**SNUPPS**

February 1, 1985  
SLNRC 85-5 FILE: 0543  
SUBJ: Wolf Creek Technical  
Specifications

Docket No. STN 50-482

FIGURE 3.2-3  
RCS TOTAL FLOW RATE VERSUS R  
FOUR LOOPS IN OPERATION

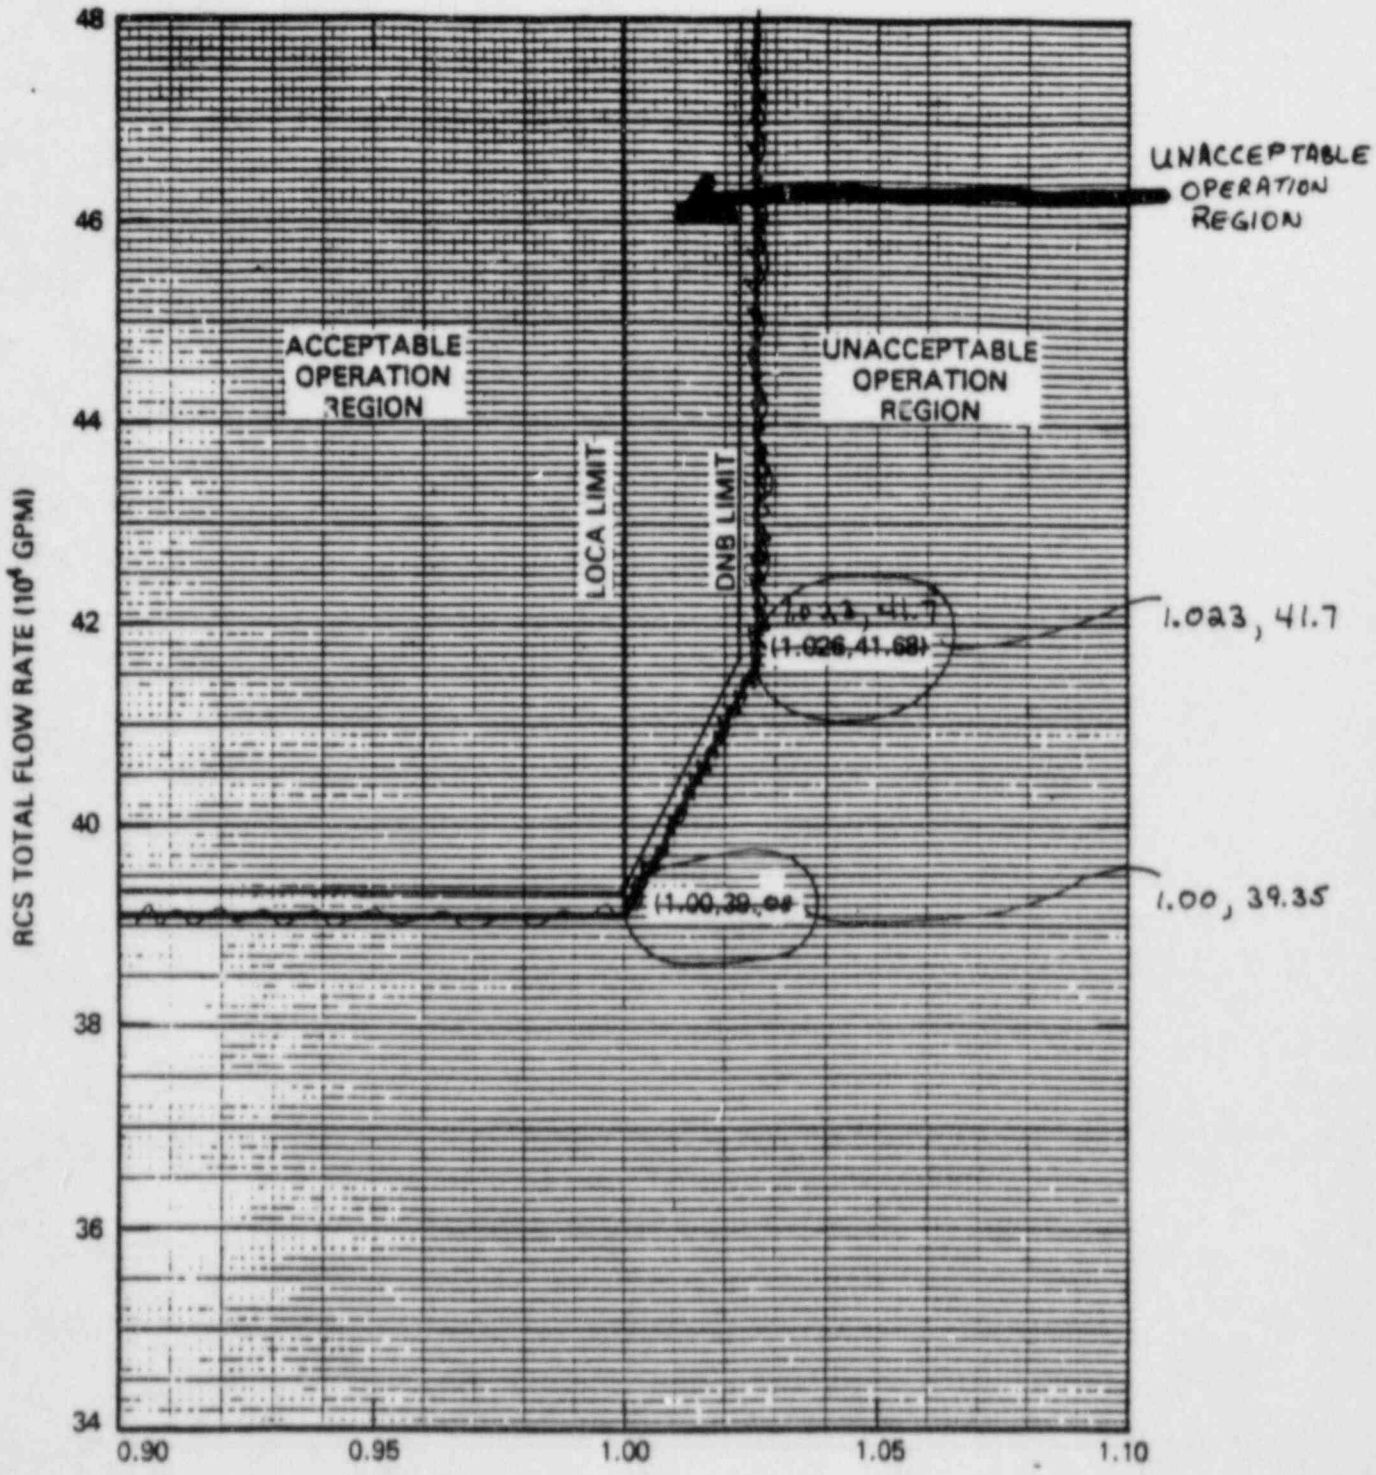
c.  $F_{\Delta H}^N$  = Measured values of  $F_{\Delta H}^N$  obtained by using the movable incore detectors to obtain a power distribution map. The measured values of  $F_{\Delta H}^N$  shall be used to calculate R since Figure 3.2-3 includes measurement uncertainties of ~~2.1%~~ 2.8% for flow and 4% for incore measurement of  $F_{\Delta H}^N$ .

MEASUREMENT UNCERTAINTIES OF <sup>28</sup>2.4% FOR FLOW AND 4.0% FOR INCORE MEASUREMENT OF  $F_{\Delta H}^N$  ARE INCLUDED IN THIS FIGURE
